YMPO AUDIT CHECKLIST NO. REECO 89-5

(1) Organization REYNOLDS ELEC. & ENGR. CO, INC.

1 Date		2 Severity Level <input checked="" type="checkbox"/> 1 <input type="checkbox"/> 2 <input type="checkbox"/> 3		Page 1 of 2	
3 Discovered During AUDIT 88-7		3a Identified By S. Dana/J. Clark	3b Branch Chief Concurrence Date		4 SDR No. 188 Rev. 0
5 Organization REECo		6 Person(s) Contacted Bob Lyken		7 Response Due Date is 20 Working Days from Date of Transmittal	
8 Requirement (Audit Checklist Reference, if Applicable) (Audit checklist item N/A) REECo QAPP 568-DOC-115, R5, Section V-1.0 states in part, "Activities affecting quality shall be prescribed by and performed in accordance with documented instructions, procedures, plans or drawings, of					
9 Deficiency Contrary to the requirements stated above, the QA administrative procedures (NQPs) governing REECos performance of NNWSI Project quality affecting work do not include or reference appropriate quantitative or qualitative acceptance

FIGURE 2

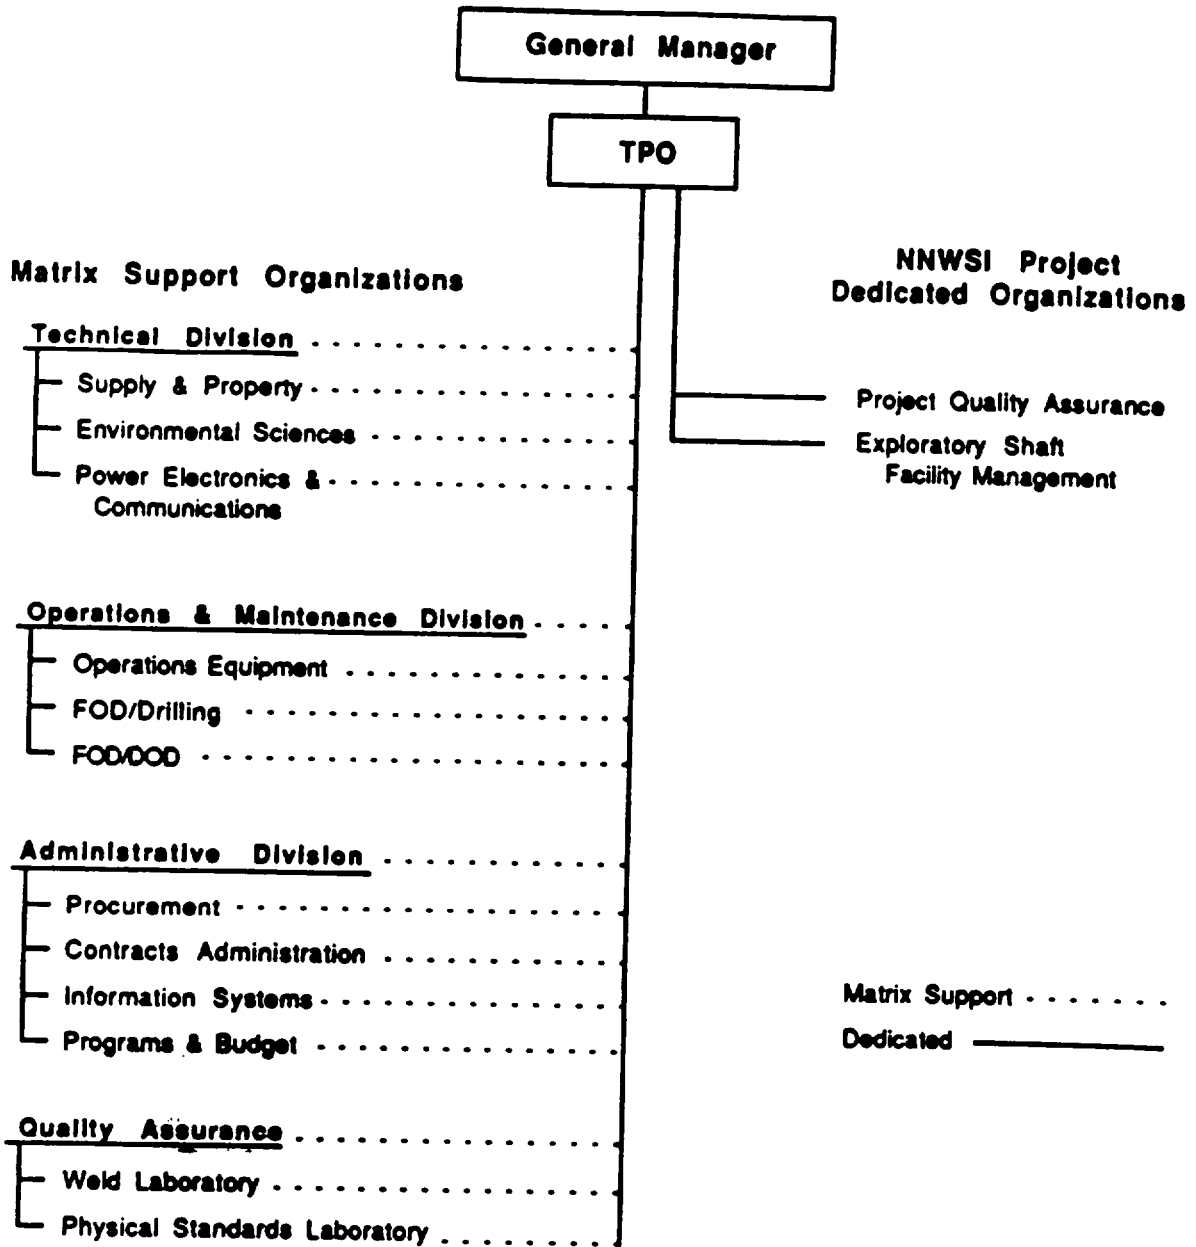
The resolution of disputes is not clearly and accurately depicted in QAPP page 9, Figure 2.

The REECO QAPP, page 9, Figure 2 (REECO Organizational Structure NWSI Project) does not show the external interface between the REECO Project QA Manager and the WMPO PQM relative to resolution of disputes. The QAPP, page 6, paragraph 2.2 states in part, "The WMPO PQM may be utilized to resolve disputes between participants"; however, the aforementioned paragraph does not delineate the REECO Project QA Manager as the interface with the WMPO PQM.

The REECO QAPP, page 9, Figure 2 should be revised to clearly show the REECO Project QA Managers interface with the WMPO PQM relative to resolution of disputes.
